City of Piedmont
COUNCIL AGENDA REPORT

DATE: November 4, 2024

SUBJECT: Consideration of an Appeal of the Planning Commission's Decision to Conditionally Approve a Design Review Permit Application (DRPC2023-016) to Renovate and Add a Second Story to an Existing Single-Family Residence at 21 Cambridge Way

Photo of the balcony from our kitchen window - look into our kitchen window

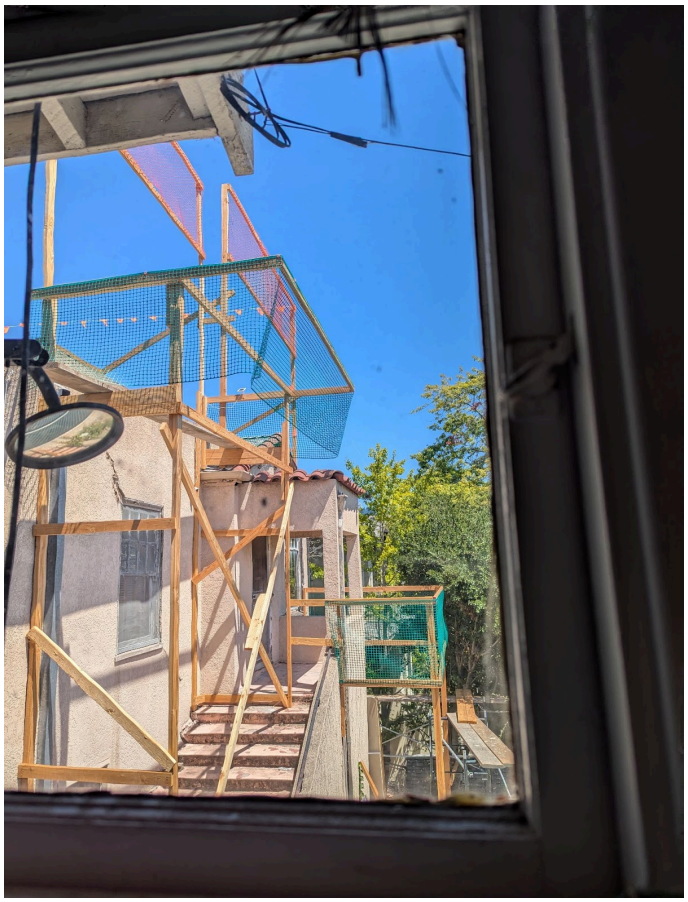
The proposed plan includes two huge front balconies, 7'x11' and 12.5'x8.5', and stairs extending towards the street that creates an oppressive towering structure. The second story balcony has a direct line of sight into our front living room and our dining room with only a few feet away/clearance; this is an absolute intrusion of our privacy. As indicated by the photos below, the second story balcony is clearly visible from our windows in the dining room, kitchen and living room. That means that people on the balcony can clearly see our activities in these areas. Imagine having people sitting/standing over there looking down directly down on your dining table. Imagine strangers peering over your shoulder in the comfort of your own house. Our privacy is obliterated by the proposed front balcony.

Photo of the proposed balcony from our dining room window - they can directly look down to our dining table
